Model	PDC-1E	Volt/Hz	Date of Modification	Serial Number
Modified Article	Parts Catalog			
Reason for Modification	Parts catalog correction

MODEL NAME	V/Hz	DESTINATION	CODE	SERIAL NUMBER
Ricoh NC8015	11 5/60	USA	A092-17	From 1st Production
Gestetner 2780	220,230, 240/50	Europe etc.	A092-22	From 1st Production
Ricoh NC8015	220,230, 240/50	Europe etc.	A092-27	From 1st Production

Page 18

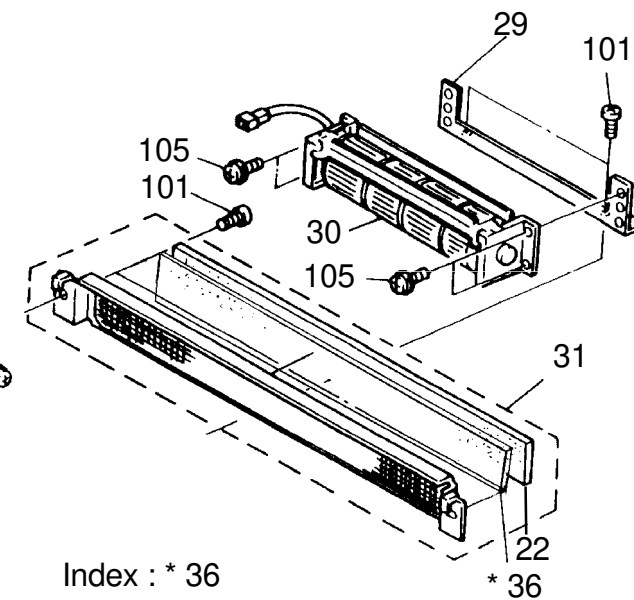
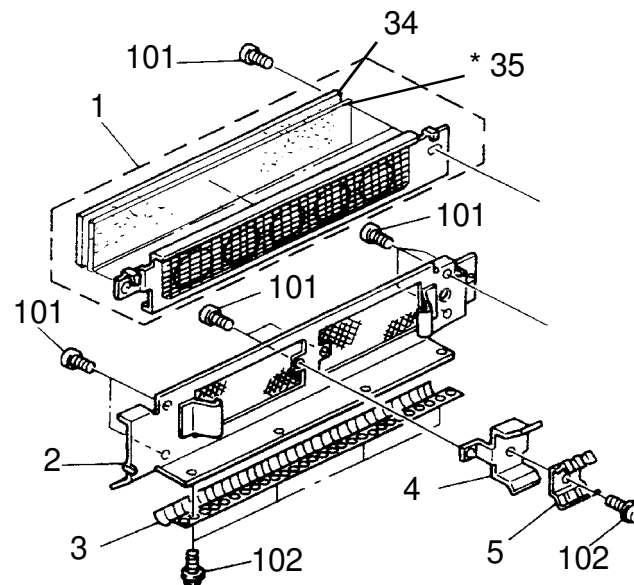
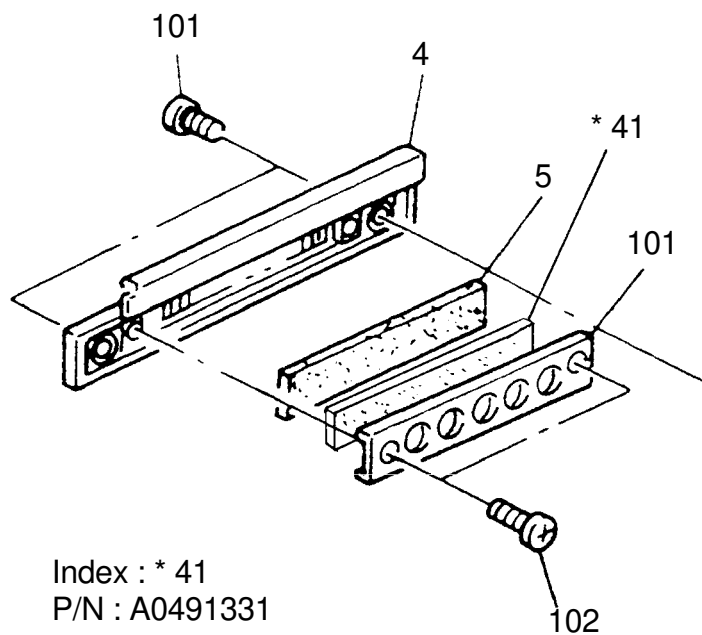
Incorrect P/N	Correct P/N	Description	Q'ty Used	Index No.	Page
A0493054	A0923054	Toner Tank Ass'y	4	9	45
A0493055	A0493056	Development Unit	1	*	41
-----	A0491331	Dust Filter - EFA-40N	1	* 41	11
-----	A0491784	Dust Filter - EFA-40N	1	* 35	19
-----	A0491792	Dust Filter - EFA-40N	1	* 36	19
AX400008	AX400033	Heater - 115V 18W	2	7 12	23 87

The "Dust Filter-EFA-40N" has to be replaced every 120K copies and these parts are called "Cooling Fan Filter" on page 4 - 1 of the S/M.

Page 14

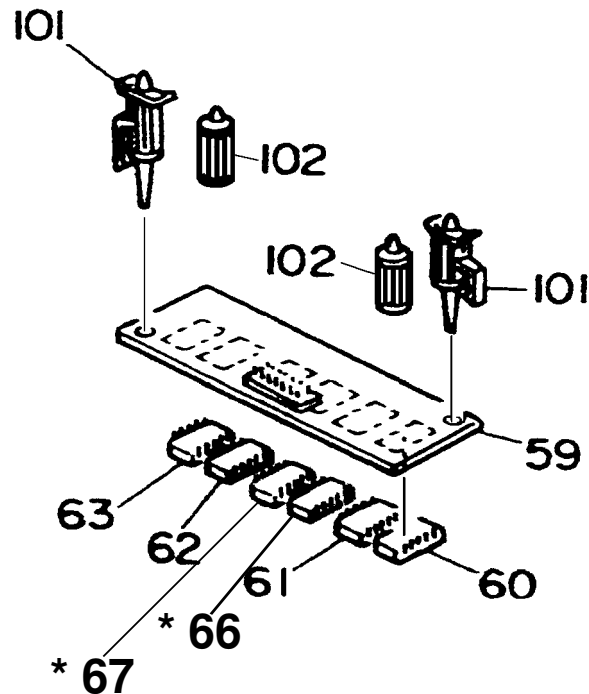
Incorrect P/N	Correct P/N	Description	Q'ty Used	Index No.	Page
-----	A0495833	Shielding Plate - Harness	1	* 28	91
-----	09514005B	Philips Screw With Flat Washer	2	* 120	91
-----	A0925855	Spacer - Door Catch	2	* 30	13
A0925460	A0925448	ROM Board (A4)	1	59	15
-----	A0925515	IC - MBM27C10001-15 (A4/LT)	1	* 66	15
-----	A0925516	IC - MBM27C10001-15 (A4/LT)	1	* 67	15

Index	IC No. on the printed board
60	IC 31
61	IC 32
* 66	IC 33
* 67	IC 34
62	IC 35
63	IC 36

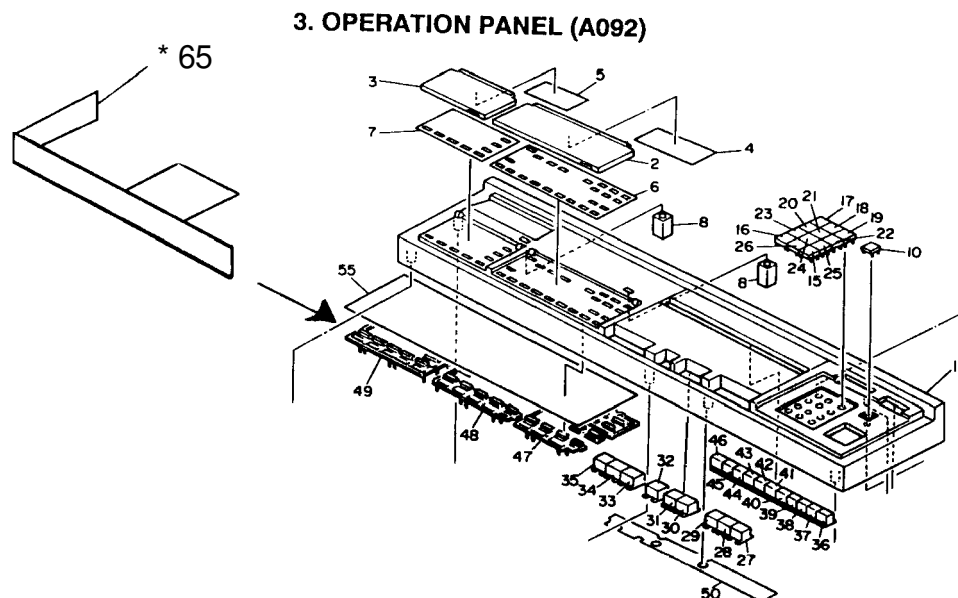
The following part has been added to the left side of the operation panel Ass'y:

Old P/N	New P/N	Description	Q'ty Used	Interchangeability	Index No.	Page
-----	A0925459	Shielding Sheet Left - A4	1	-----	* 65	15

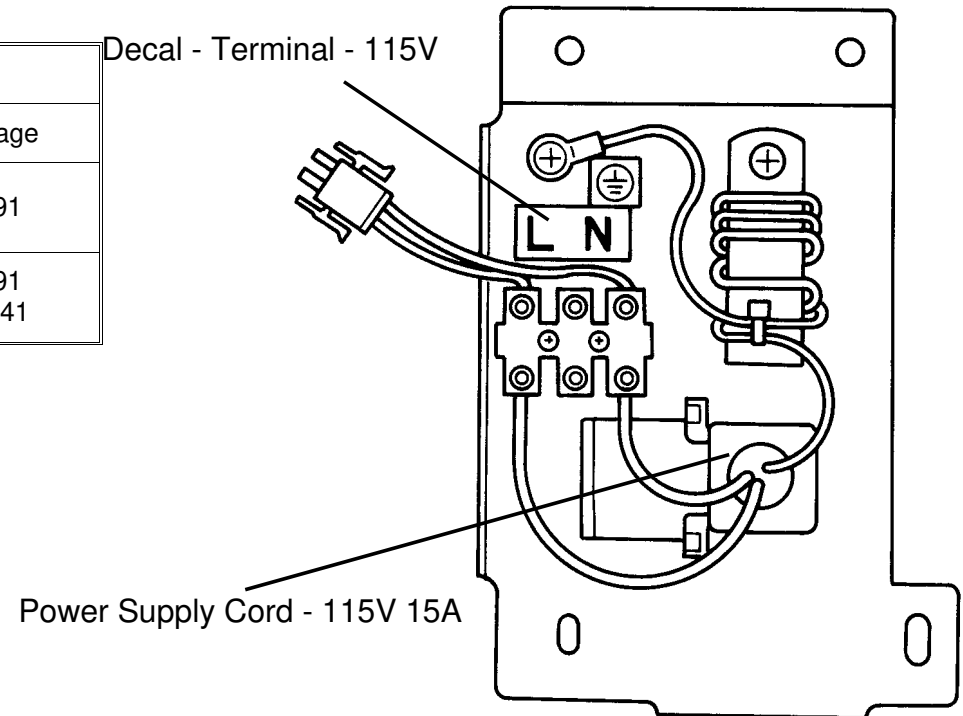
P/N	Description	Q'ty Used	Parts Catalog	
			Index No.	Page
AZ000034	Power Supply Cord - 115V 15A	0 → 1	8	91
52115809	Decal - Terminal - 115V	0 → 1	* 30 * 38	91 141

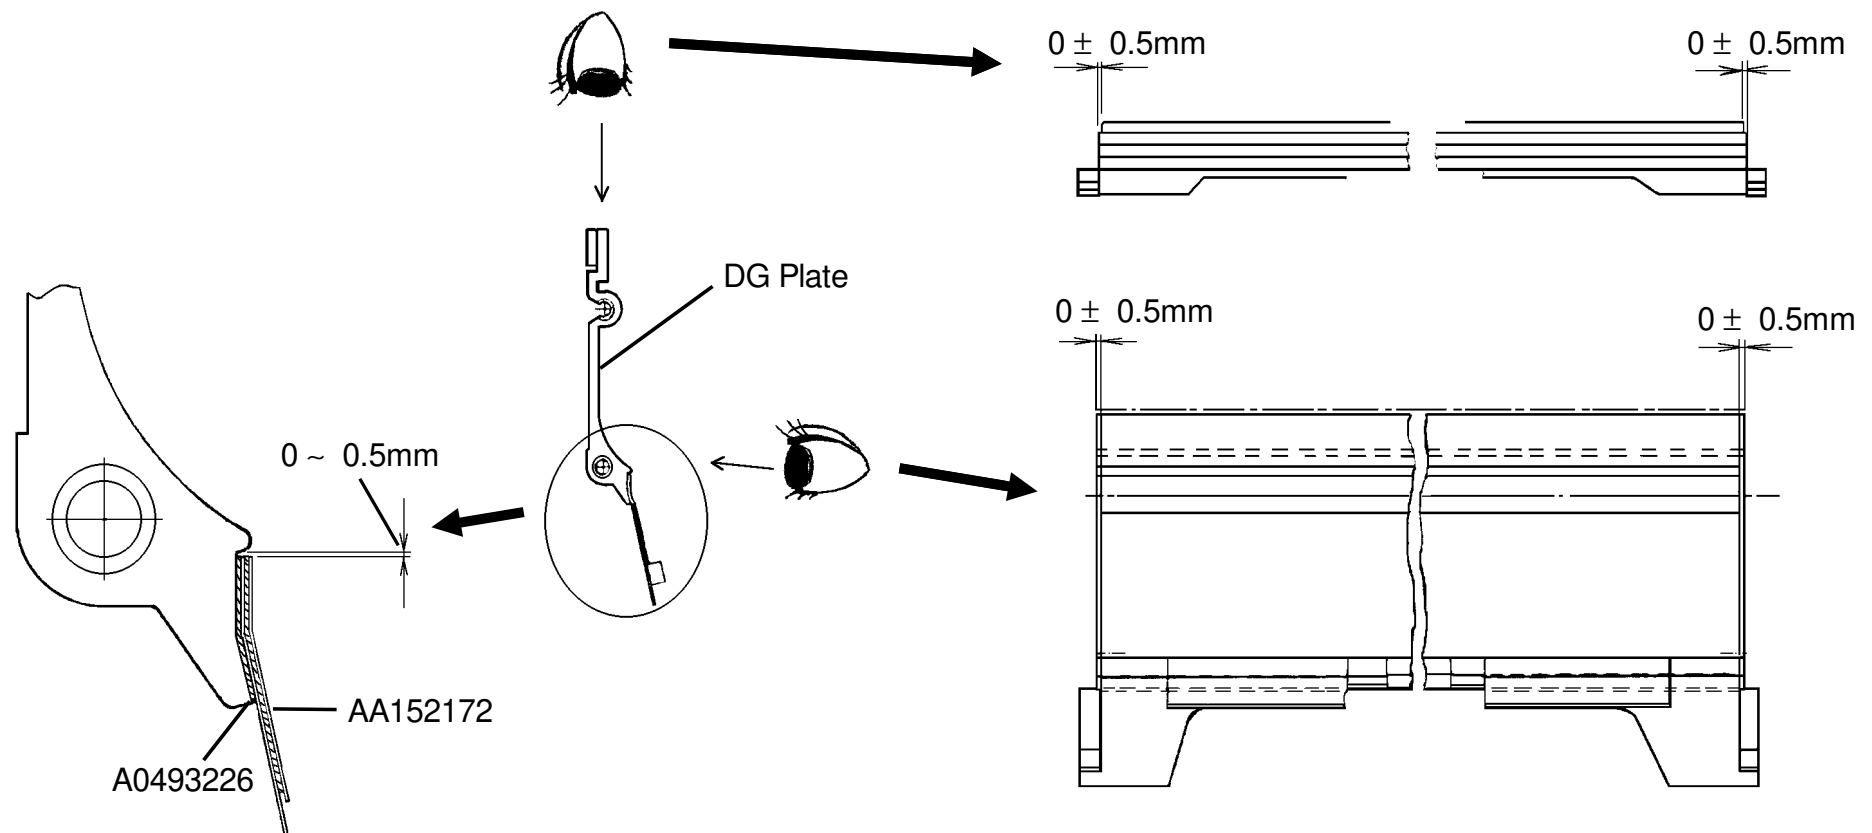
As per request from field, a mylar and a both sides tape to stick the mylar to a doctor plate have been registered as service parts.

Part number	Description	Q'ty Used	Parts Catalog	
			Index No.	Page
AA152172	Doctor Plate Mylar	0 → 1	40	43
A0493226	Tape	0 → 1	41	43

Note: AA152172 and A0493226 are components of Doctor Plate (A0493067).

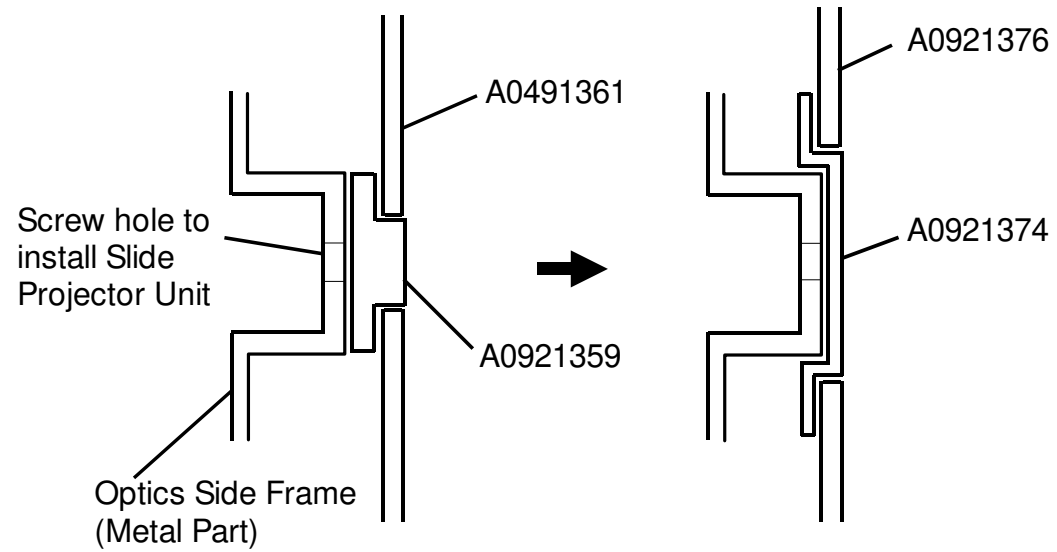
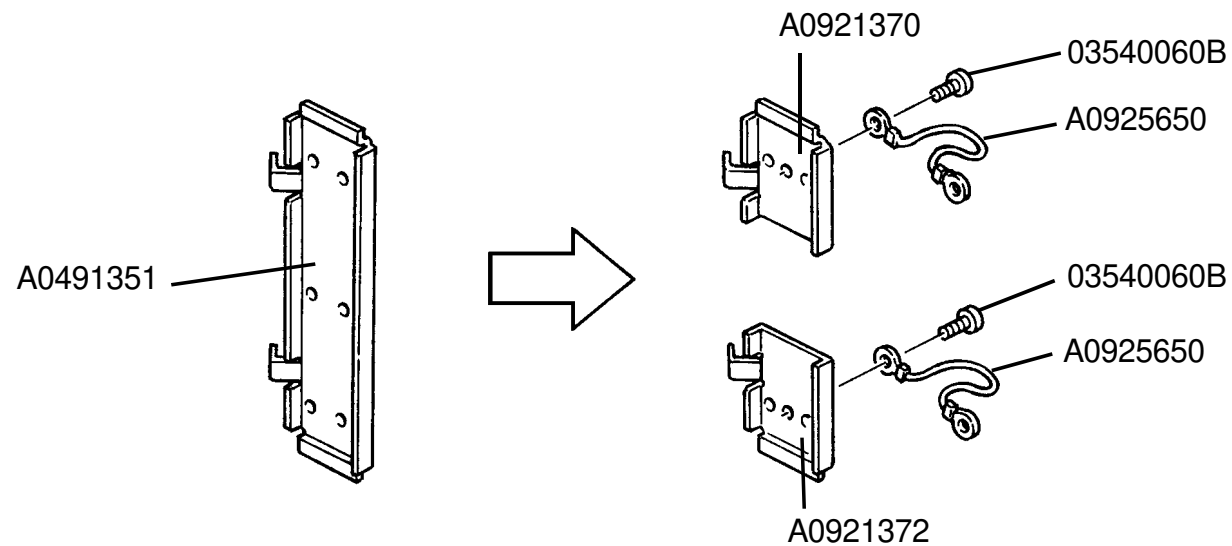
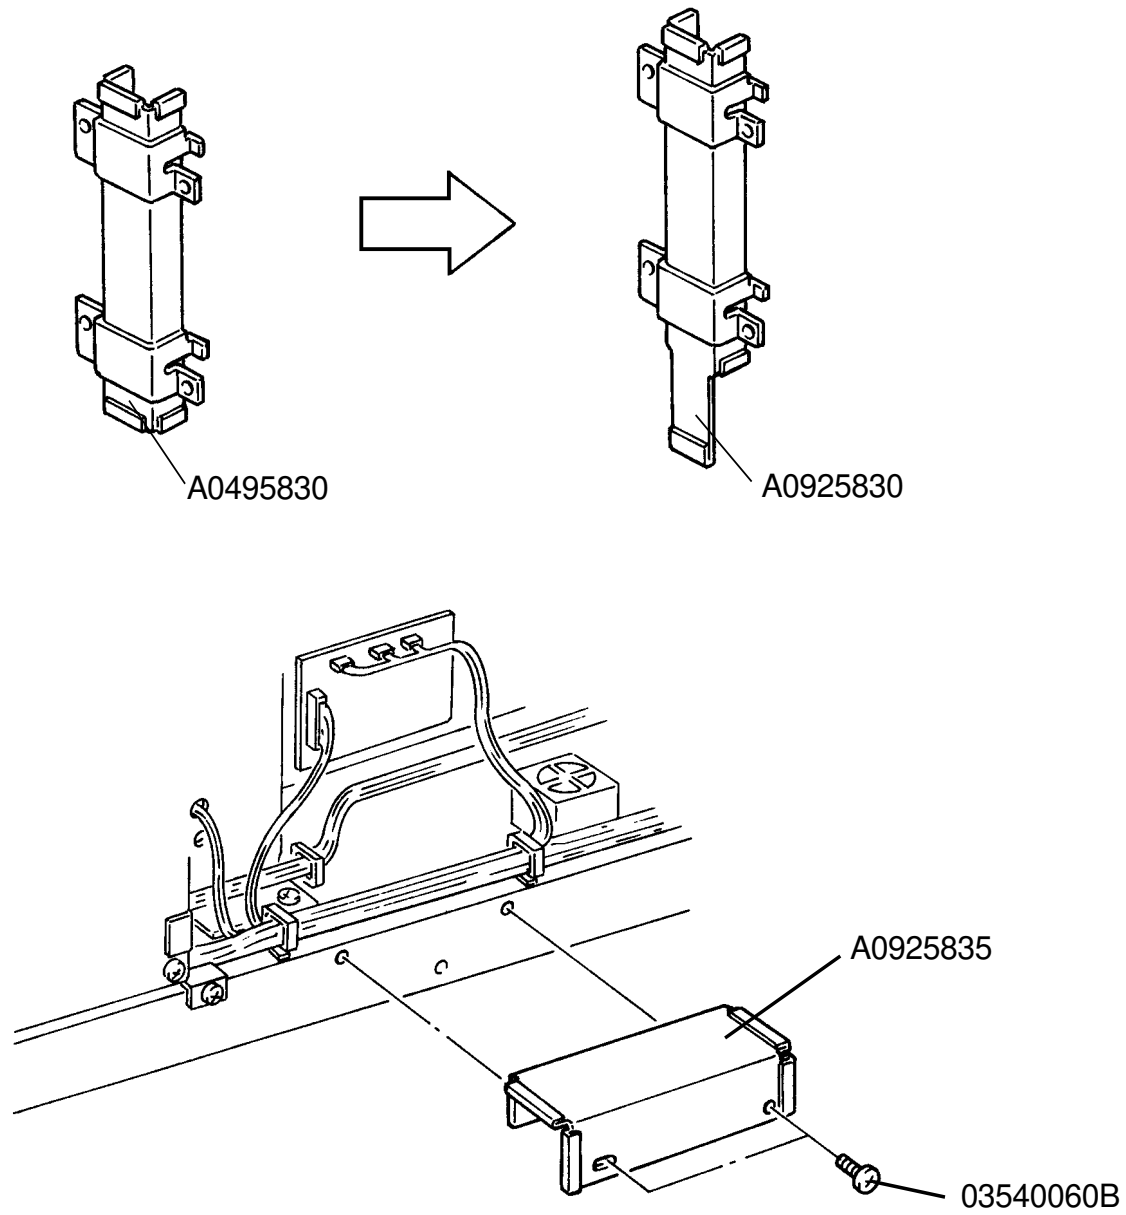
Model		PDC - 1E						Volt/Hz	Date of Modification	Serial Number	
Modified Article		Brackets etc.									
Reason for Modification		To improve electrical noise margin									
Draw No.	Old Parts No.		New Parts No.	Description	A.B.C.	Q'ty Used Old → New	Inter-change-ability	Part needed for replacement by new part		Parts Catalog	
					Rank			Part No.	Description	Index No.	Page
	A0491361		A0921376	Right Cover Cap		2 → 2	X/X		X/O as a set	21	11
	A0921359		A0921374	Upper Right Cover		1 → 1	X/X			20	11
	A0491351			Front Right Cover Bracket		1 → 0	X/			23	11
			A0921370	Front Right Cover Bracket - Upper		0 → 1	/X			* 42	11
			A0921372	Front Right Cover Bracket - Lower		0 → 1	/X		X/O as a set	* 43	11
			A0925650	Grand Wire		0 → 2	/X			* 44	11
			03540060B	Philips Pan Head Screw - M4 x 6		n → n+ 2	/X			102	11
	A0495830		A0925830	Harness Clamp		1 → 1	X/O			11	91
			A0925835	Bracket - Harness Cover		0 → 1				* 29	91

03540060B	Philips Pan Head Screw - M4 x 6		n → n+ 2				101	91

* By this modification, contact area of metal parts between PDC-1E and Slide Projector Unit is increased result in better grounding.

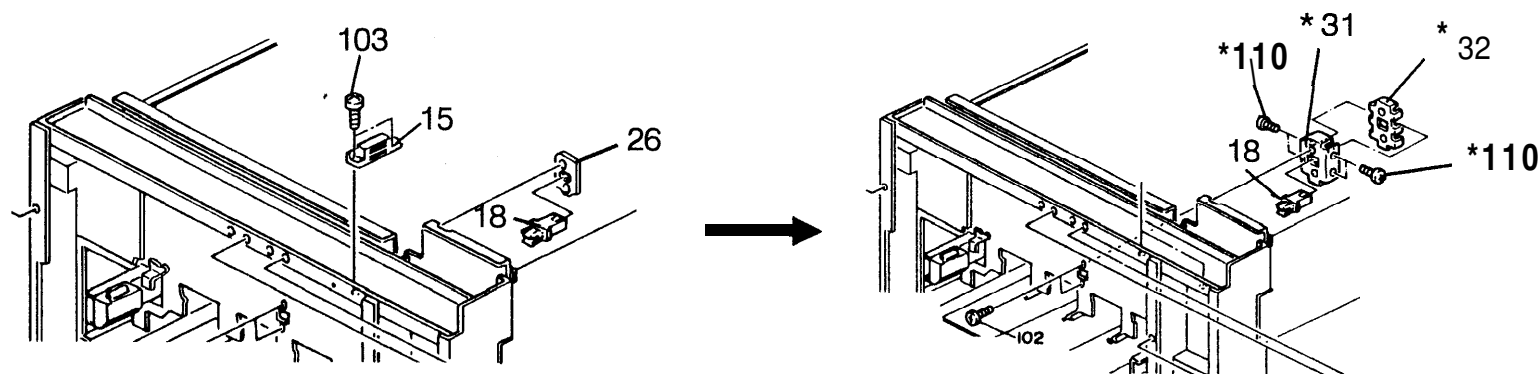
Model		PDC-1E						Volt/Hz		Date of Modification		Serial Number	
Modified Article		Latch Bracket											
Reason for Modification		Due to the field request											
Draw No.	Old Parts No.		New Parts No.	Description	Rank	Q'ty Used Old → New	Inter-changeability	Parts needed for replacement by new part		Parts Catalog			
								Part No.	Description	No.	Page		
	A0493281	—		Latch Bracket		1 → 0					26	13	
			A0493381	Bracket - Latch		0 → 1		— X/O			* 31	13	
			A0493382	Bracket - Release - Latch		0 → 1					* 32	13	
			03130350B	Philips Pan Head Screw - M3 x 35		n → n + 2					*110	13	
										*New Index No.

If the latch which holds the toner transport unit in position is broken, it takes long time just to replace this part. For example, the laser unit has to be replaced. To reduce the time for the replacement of this parts, the following brackets have been added. Then, it is possible to replace the latch without removing the laser unit. The latch (# A0493282) has not been changed.

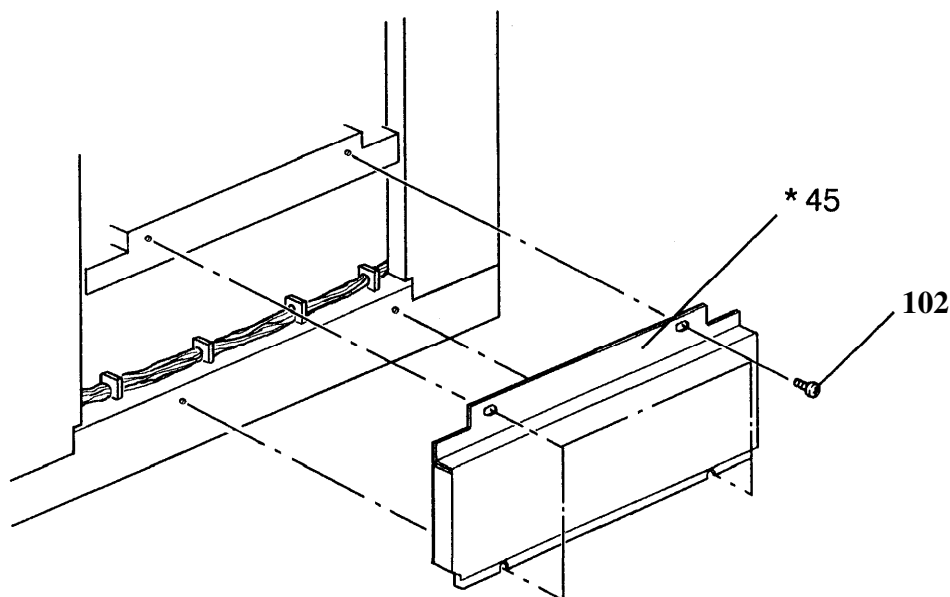
Model	PDC-1E	Volt/Hz	Date of Modification	Serial Number
Modified Article	Inner Cover			
Reason for Modification	To meet VDE class B standard

New P/N	Description	Q'ty Used	Parts Catalog	
			Index No.	Page
A0921099	Inner Cover	0 → 1	* 45	11
03540060F	Philips Pan Head Screw - M4 x 6	n → n + 4	102	11

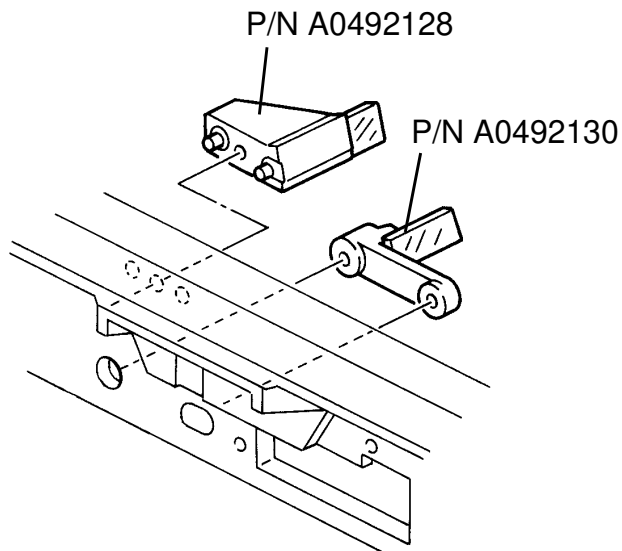
To meet field requests, the 1st and 2nd synchronizing mirrors in the laser unit assembly have been registered as service parts.

Old P/N	Description	Q'ty Used	Parts Catalog	
			Index No.	Page
A0492128	1st Synchronizing Mirrors	0 → 4	* 27	29
A0492130	2nd Synchronizing Mirrors	0 → 4	* 28	29
